ERRATA SHEET FOR ANSI/ASHRAE/IES STANDARD 90.1-2013 (SI Edition) Energy Standard for Buildings Except Low-Rise Residential Buildings

March 17, 2025

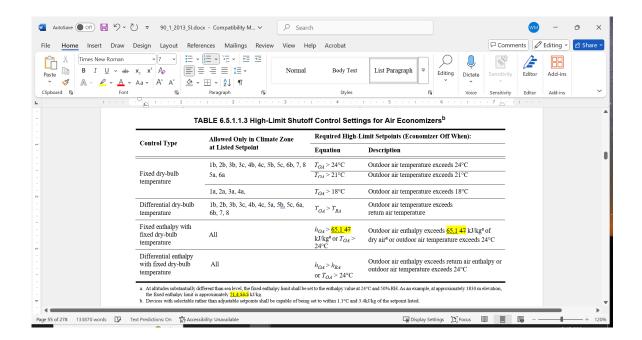
- **TABLE 6.5.1.1.3 High-Limit Shutoff Control Settings for Air Economizers.** Revise Table 6.5.1.1.3 as shown in the attached.
- **Section 6.5.3.1.3 Fan Efficiency.** In Exceptions 1 and 2 to Section 6.5.3.1.3 change the word "horsepower" to "kW".
